**Southern Nuclear  
Operating Company, Inc.**  
40 Inverness Center Parkway  
Post Office Box 1295  
Birmingham, Alabama 35201

NL-03-1696

**Joseph M. Farley Nuclear Plant Units 1 and 2  
Request to Revise Service Water Intake Structure  
Exemption from Fire Protection Requirements at Farley Nuclear Plant**

**Figure B-1 – Farley SWIS Fire Area 72 – Simplified Layout**

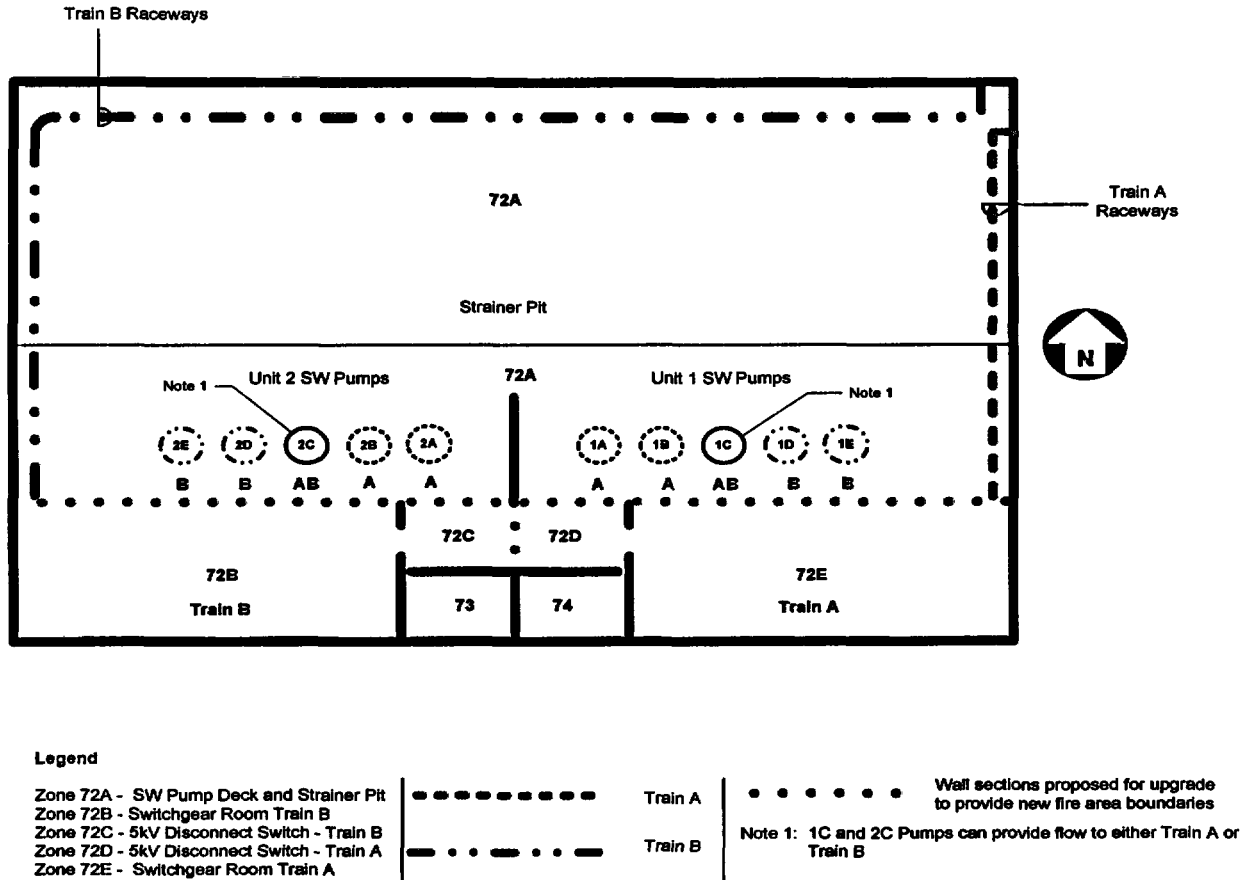
As shown in Figure B-1, most of the SWIS is designated as Fire Area 72. Fire Area 72 is comprised of five fire zones:

- Zone 72A – Service Water Pump Deck and Strainer Pit
- Zone 72B – Switchgear Room Train B
- Zone 72C – 5kV Disconnect Switch – Train B
- Zone 72D – 5kV Disconnect Switch – Train A
- Zone 72E – Switchgear Room Train A

SNC also intends to upgrade the nominal 18-inch concrete wall between Fire Zone 72A and Fire Zones 72B, C, D and E to meet the requirements of FNP's Fire Protection Program for a minimum 3-hour fire area boundary. Penetrations will be sealed, un-rated doors will be replaced by 3-hour rated fire doors, and three new fire areas will be created, 72A, 72B/72C and 72D/72E. These changes will provide cost-effective improvements in fire safety and will eliminate potential fire propagation paths between the pump deck and switchgear rooms, as well as between redundant switchgear rooms. These changes will provide additional defense-in-depth, supporting the elimination of the need for Kaowool barriers in fire area 72A because cables in that fire area will be protected from fires in fire areas 72B/72C and 72D/72E by the passive features of the upgraded wall.

In addition, a new curb on the Unit 1 pump deck will be installed to prevent liquid spill fires associated with the Unit 1 pumps from pooling beneath the Train A cable tray located near the east wall.
